**CITY OF TEMPE  
DEVELOPMENT REVIEW COMMISSION**

**Meeting Date: 04/28/2015**

**ACTION:** Request for a Development Plan Review for building elevations, site plan and landscape plan, and a Use Permit Standard for an increase in building height from 30 to 33 feet, consisting of 15 single family attached townhomes for THE BLOCK ON ROOSEVELT, located at 233 South Roosevelt Street. The applicant is Scott Garvin of Intent Development Advisors.

**BACKGROUND INFORMATION:** THE BLOCK ON ROOSEVELT (PL140336) is a multi-family residential through lot within the Riverside Neighborhood Association. The request includes the following:

**SITE PLAN**  
SCALE: 1/16" = 1'-0"

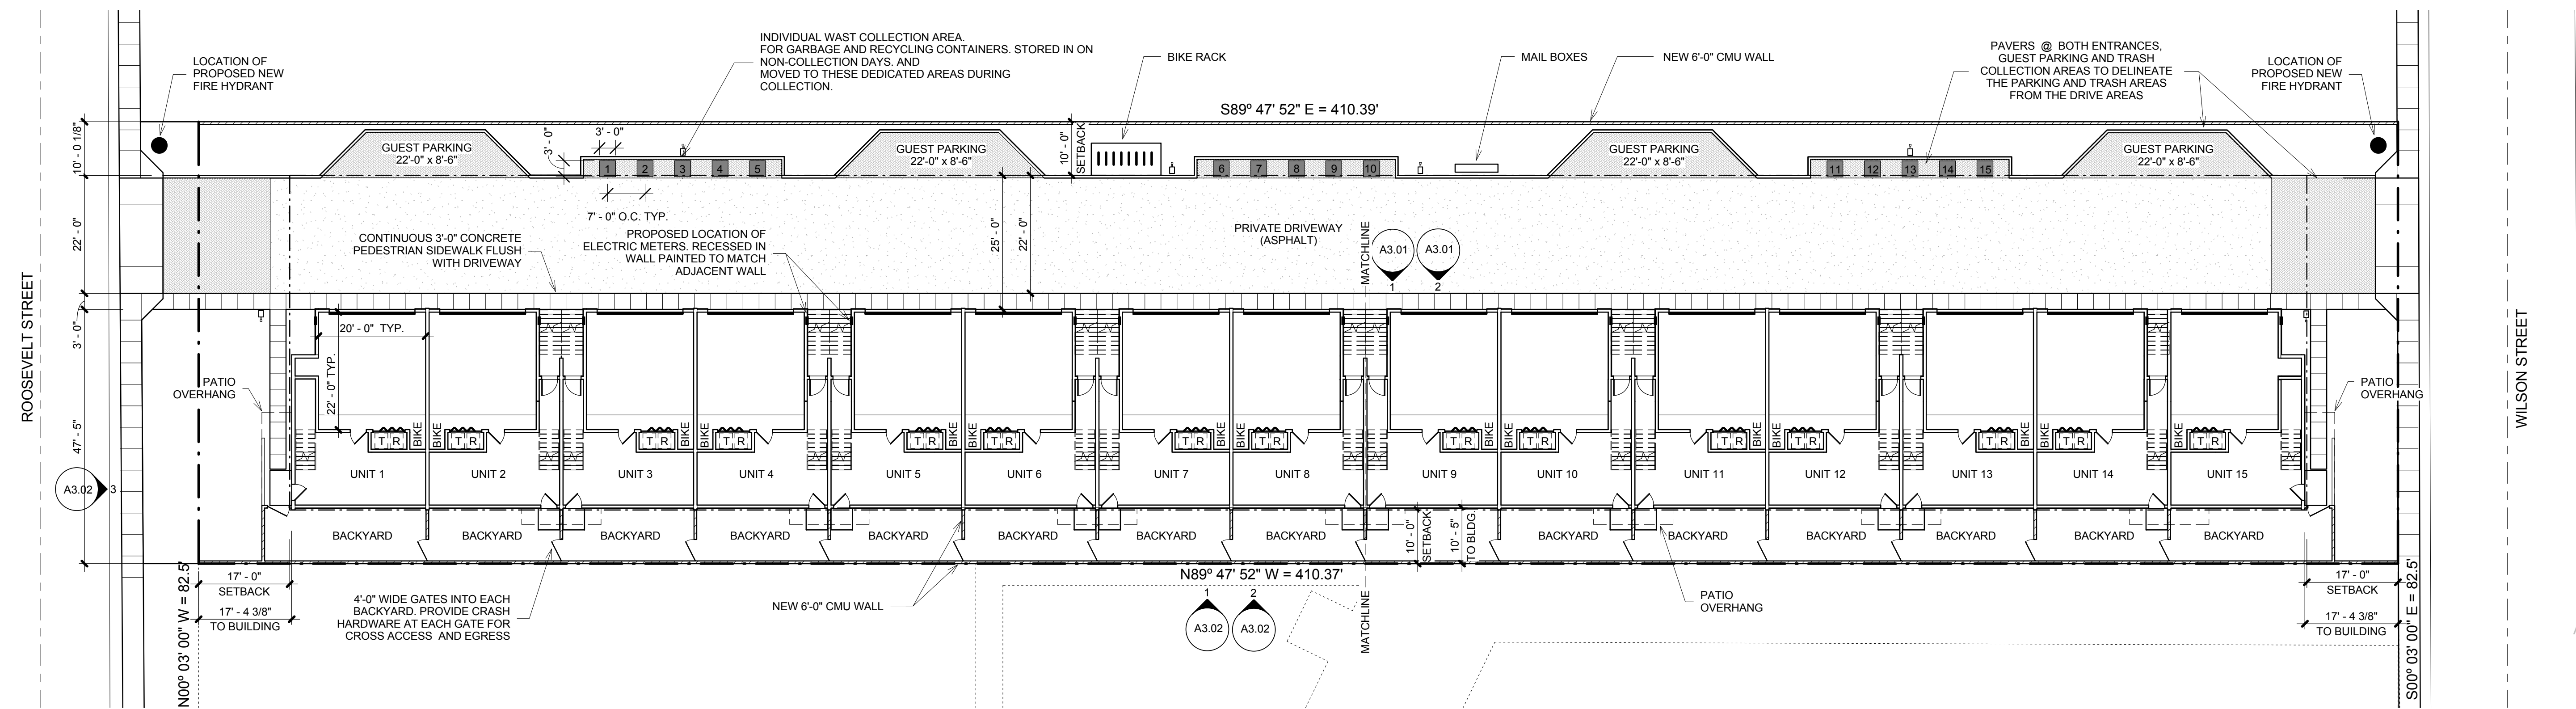
2. The site plan is approved as submitted (April 14, 2015), minor modifications may be reviewed through the plan check process of construction documents; major modifications will require submittal of a Development Plan Review.

3. Refuse and recycling containers shall be stored within the garages. On collection day, refuse containers must be placed on designated spaces identified by address and by change of surface material to assure adequate operational spacing for refuse collection.

8. Provide upgraded paving at each driveway consisting of unit paving. Extend this paving in the driveway from the right-of-way line to 20'-0" on site and from curb to curb at the drive edges. From sidewalk to right-of-way line, extend concrete paving to match sidewalk.

- ENGINEERING:
  - Grading and Drainage Plans require dual-chamber retention wells (per prior Site Plan Review comments) not single-chamber as shown on plans.

LANDSCAPE PLAN  
SCALE: 1/16" = 1'-0"

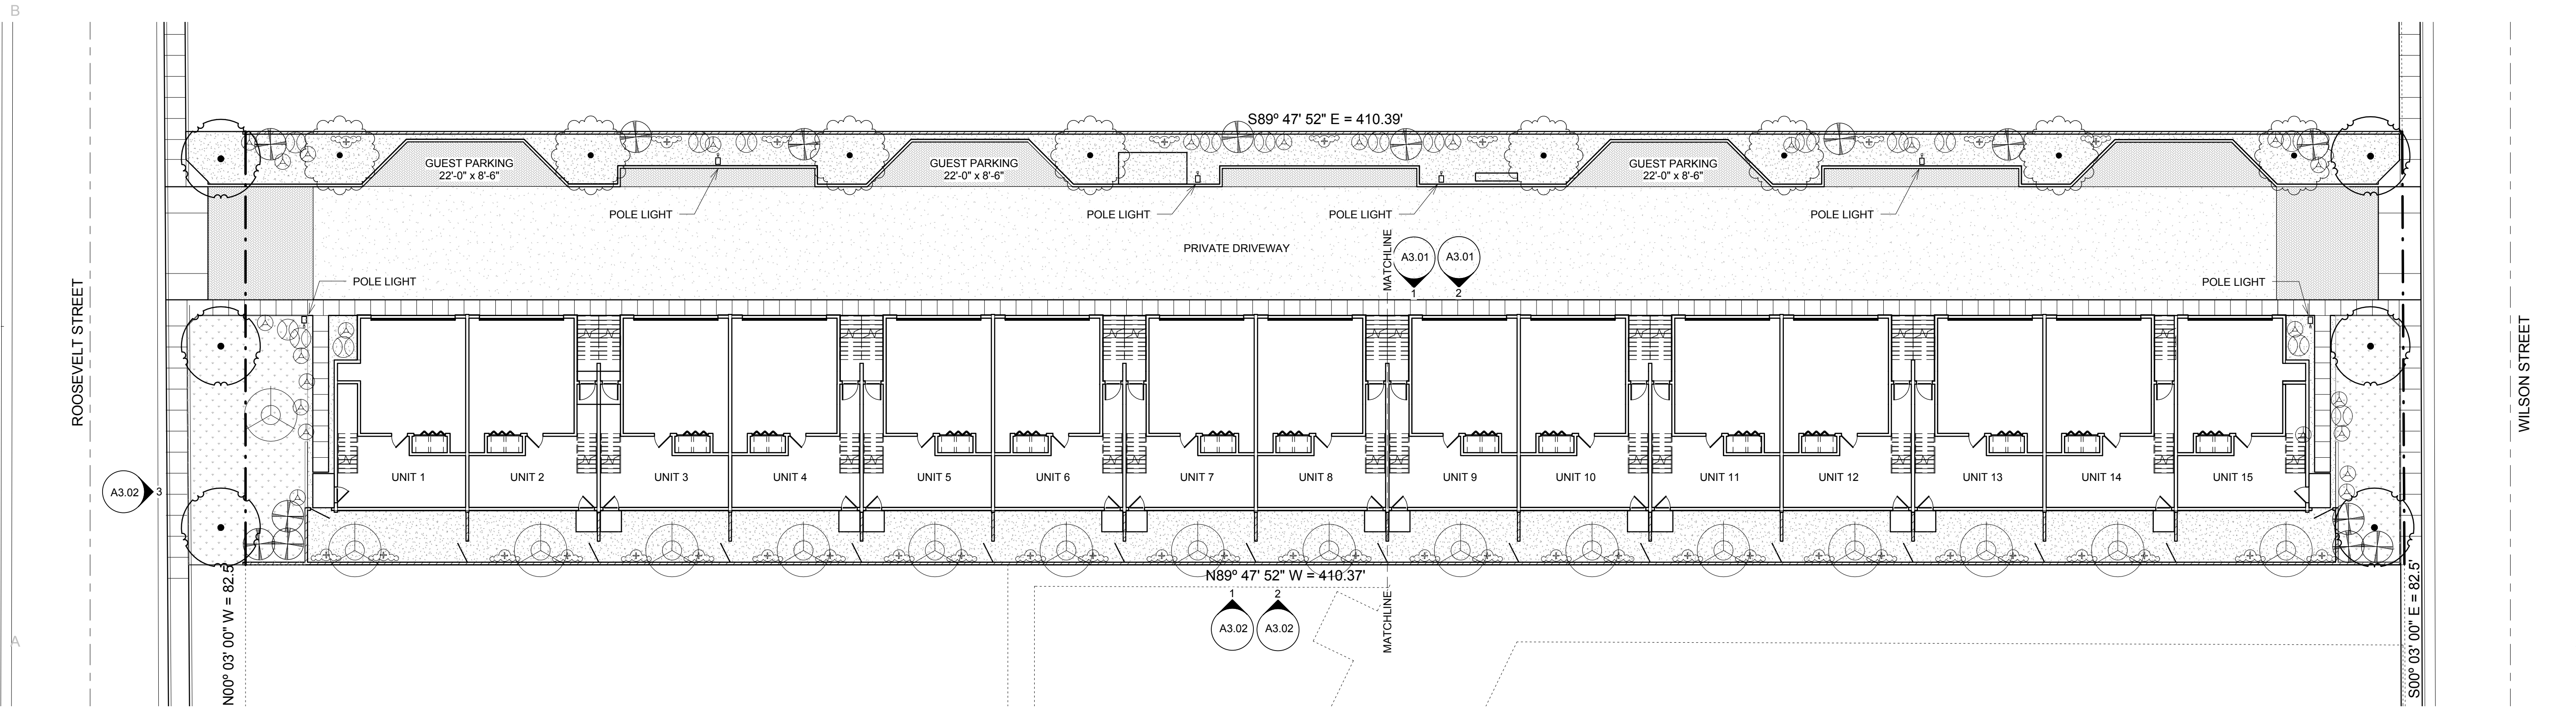
20. The plant palette is approved as proposed and specified on the landscape plan. An alternate tree species shall be provided for the south perimeter private yards, to provide a non-toxic patio tree variety as an option to residents. Any additions or modifications may be submitted for review during building plan check process.

- DRIVEWAYS:
  - Construct driveways in public right of way in conformance with Standard Detail T-320.
  - Correctly indicate clear vision triangles at both driveways on the site and landscape plans. Identify speed limits for adjacent streets at the site frontages. Begin sight triangle in driveways at point 15'-0" in back of face of curb. Consult Intersection Sight Distance memo, available from Traffic Engineering if needed [www.tempe.gov/index.aspx?page=801](http://www.tempe.gov/index.aspx?page=801). Do not locate site furnishings, screen walls or other visual obstructions over 2'-0" tall (except canopy trees are allowed) within each clear vision triangle.

**NORTH ELEVATION UNITS 9-15**

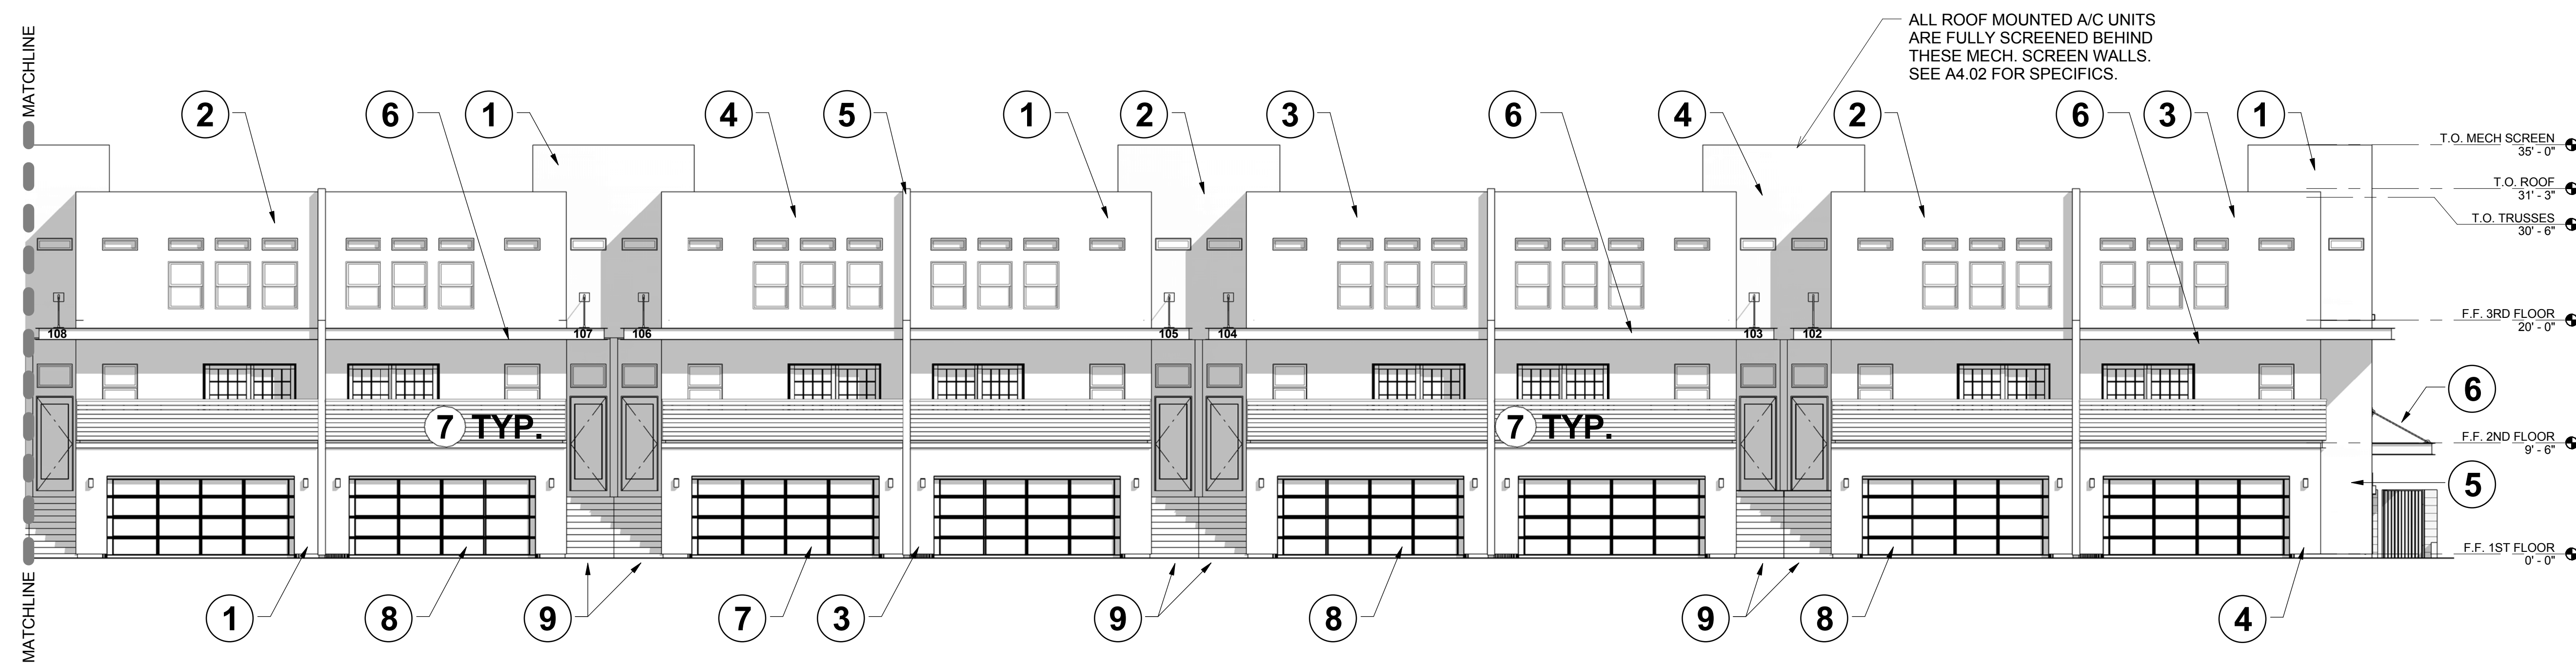
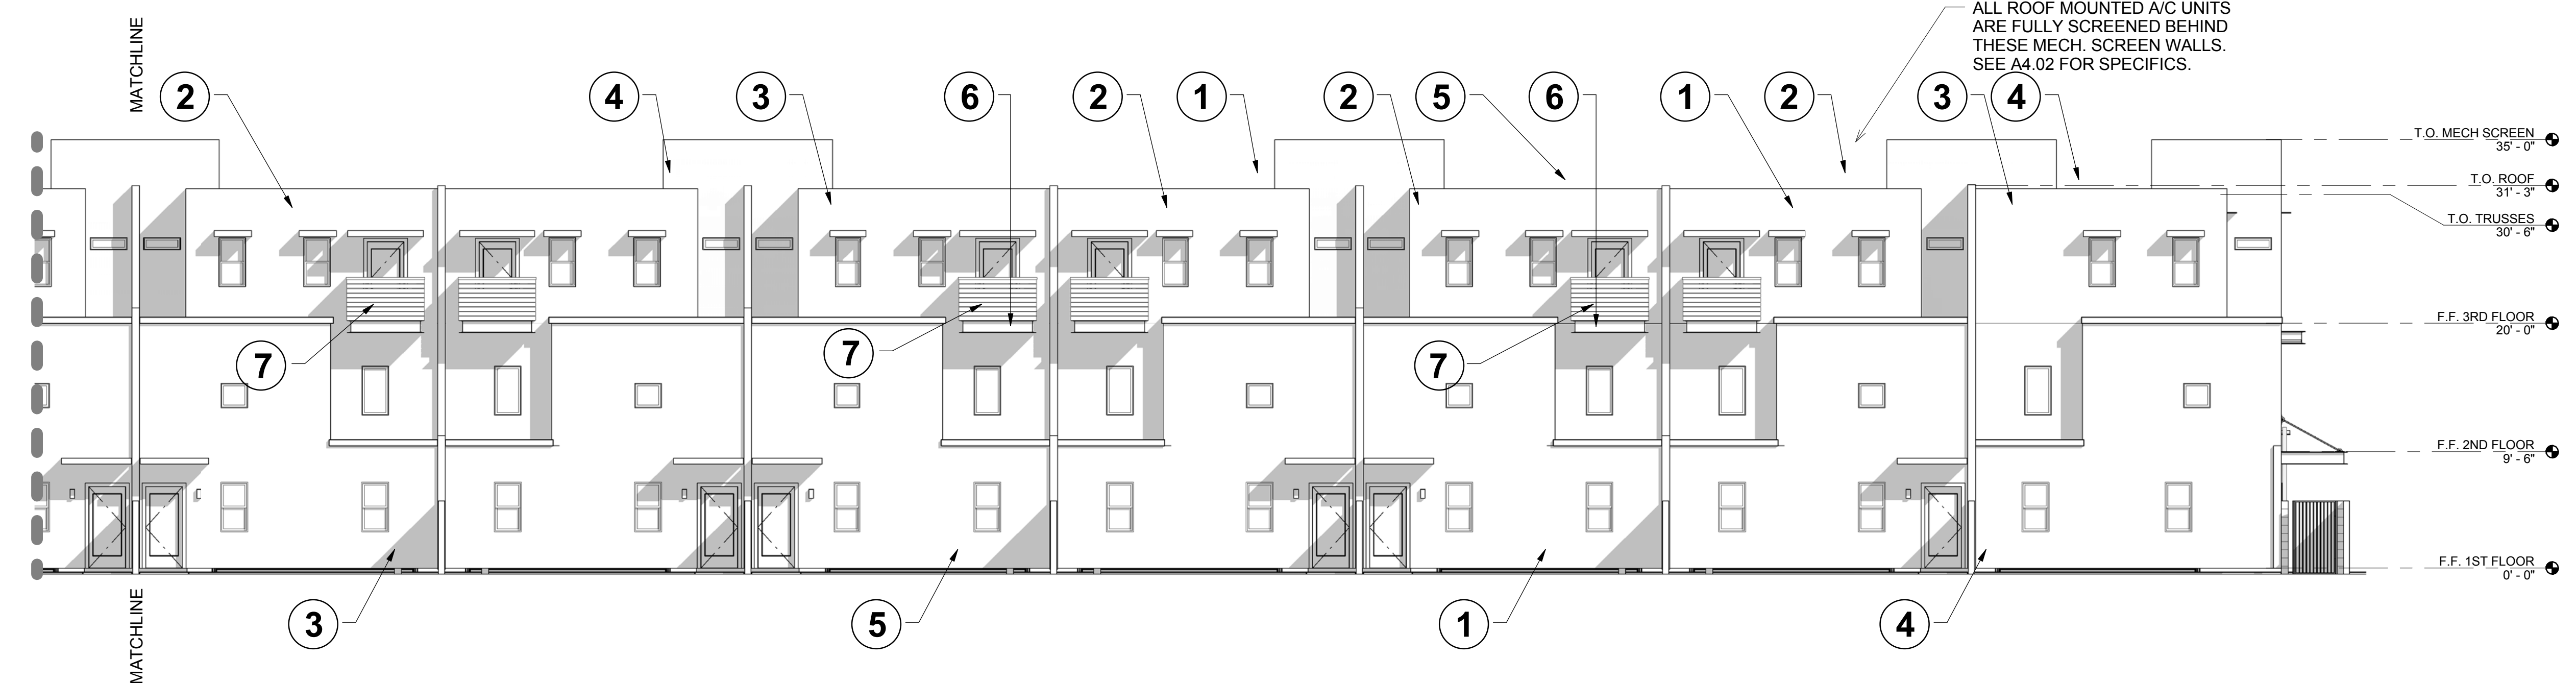
13. The materials and colors are approved as presented (April 14, 2015) with exceptions as noted:
  - Roof – flat painted white, with parapet screening of HVAC

- Primary Building – Painted Stucco Color #1 Sherwin Williams 6007 White Smart (pale mauve)  
Provide an alternate color within a contrasting color tone such as blue or green in the same tonal range (as presented on earlier April 10, 2015 elevations)

- Primary Building – Painted Stucco Color #4 Sherwin Williams 6013 Bitter Chocolate (dark brown) – provide this color as an accent color, not primary building color

- Smooth-faced CMU standard grey to be replaced with split or ground faced CMU on first floor, and integral colored block for the building elevations for enhanced architectural detail.
